Access Compliance Report

Public Rights-of-Way

(Island Curb Cuts)

Intersection ID: 17169	Main Street: IDLEWILD_RD	Cross Street: CEDARS_EAST_CT	Location: SE
ADA ID: 6BAA4479AE0F	Curb Cut Type: MedianRefuge2	Initial Pass/Fail: Fail	Overall Compliance: No
Codes/Mitigation Info/Possible Solution		Field Measurements/Component Compliance	
Severity Score: 0

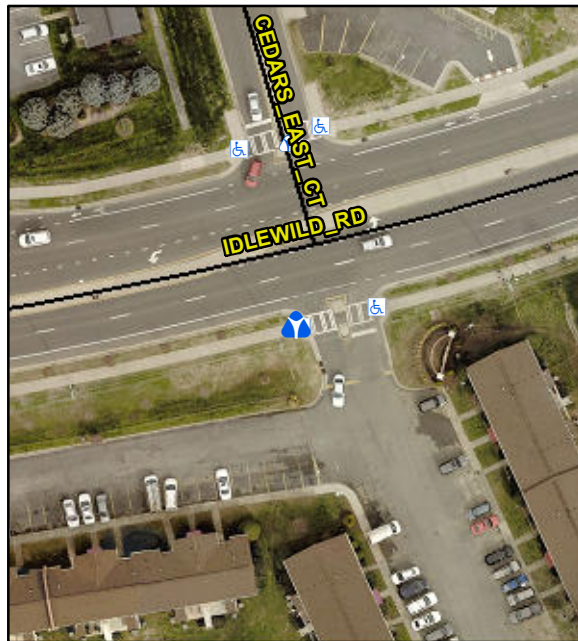
Remove & Replace Entire Refuge.
